ADDENDUM No. 1

PROJECT: BSA Hospital PET/CT Infill
1600 Wallace Blvd.
Amarillo, TX 79106

DATE: 03/07/2025
PROJECT NO.: 22418

**BSA HOSPITAL
PET/CT INFILL EQUIPMENT AND MATERIAL TRAVEL PATH TO MECHANICAL ROOM.**

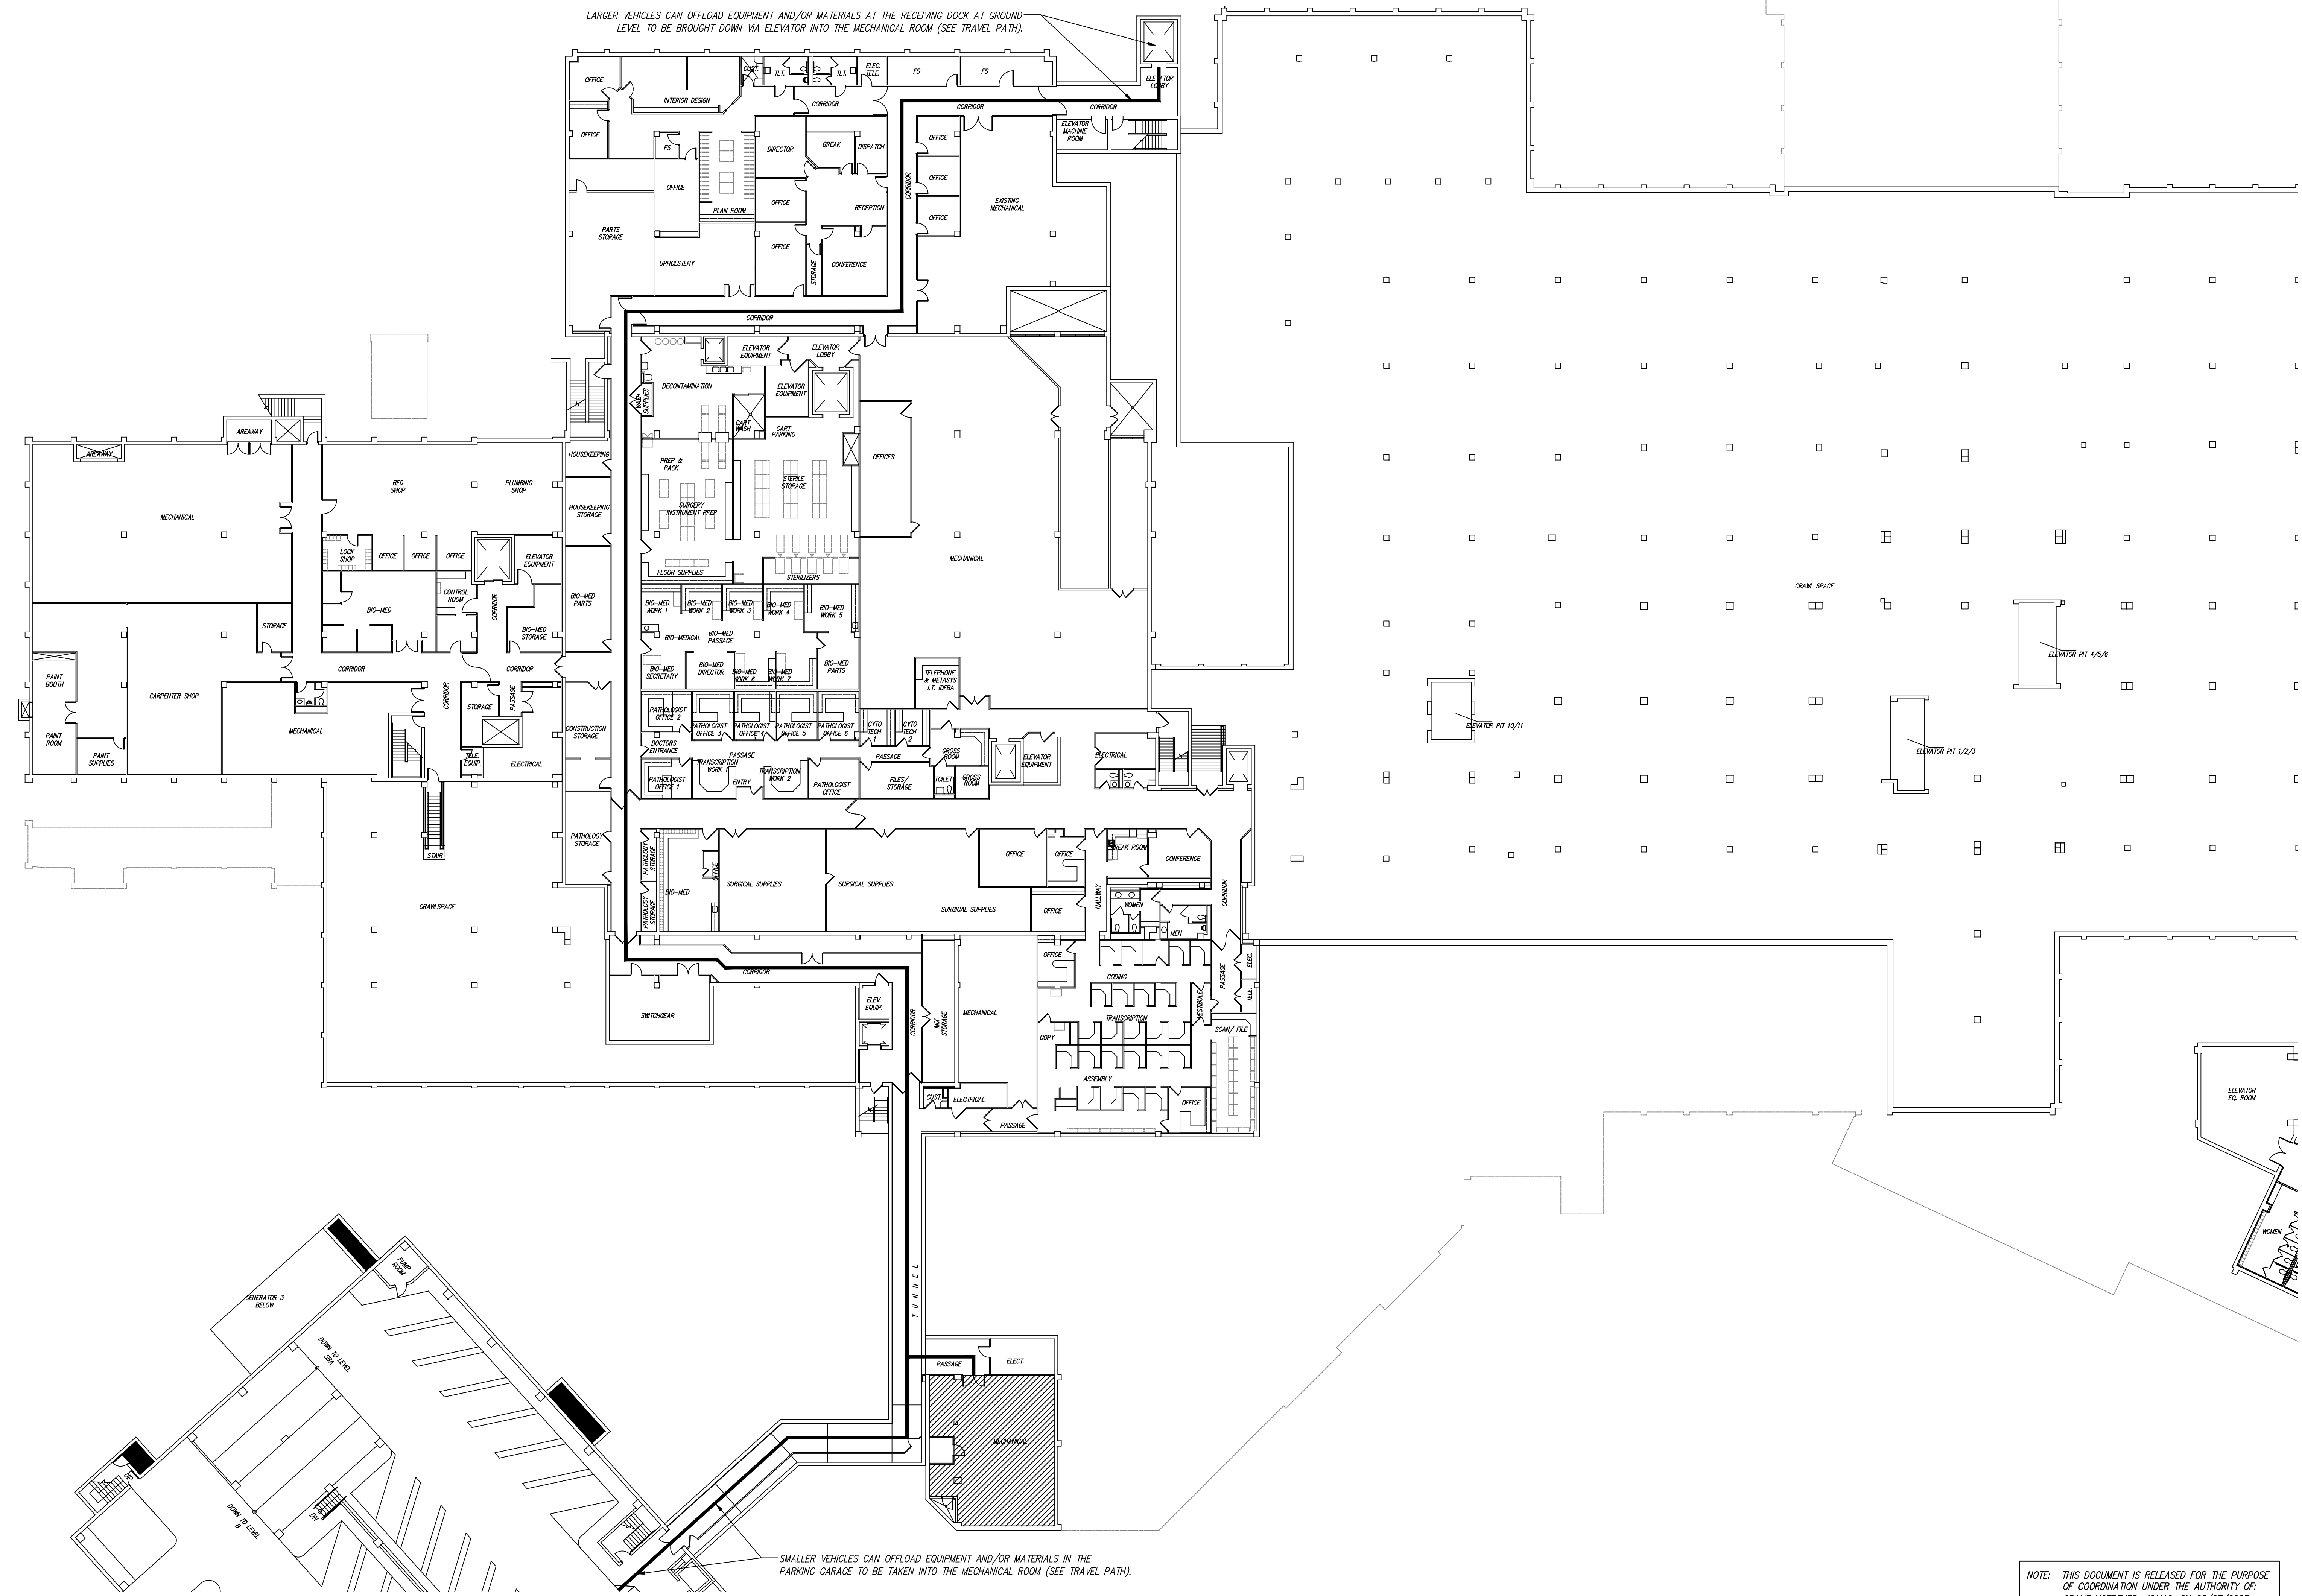
ITEM #10: Contractor Access and vehicle access – Refer to the attached drawings providing information on Contractor Access and vehicular access to deliver materials to the basement.

LARGER VEHICLES CAN OFFLOAD EQUIPMENT AND/OR MATERIALS AT THE RECEIVING DOCK AT GROUND LEVEL TO BE BROUGHT DOWN VIA ELEVATOR INTO THE MECHANICAL ROOM (SEE TRAVEL PATH).
